A cycle route on Walter Road

Introduction

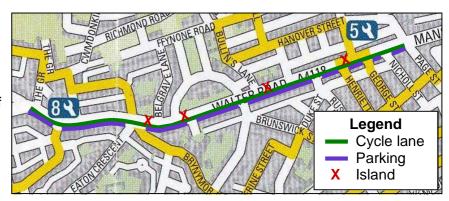
We noted that if parking was provided on the same side as a cycle lane (as shown on the plan above) a buffer between the footway and the cycle lane would be needed to safeguard cyclists from 'dooring'. (A buffer is shown on the Council drawing for the single lane option.)

We noted that the traffic islands (X's on the plan) would interrupt the cycle lane(s), continuity of which we felt important. We thought that replacement of these by single stage crossings would allow both continuity and the free movement of traffic.

- A single one way cycle lane should be provided on the uphill (south) side.
- Parking should be restricted to this side.
- The cycle lane should be at least 2m wide.
- The traffic islands should be replaced by single stage crossings.
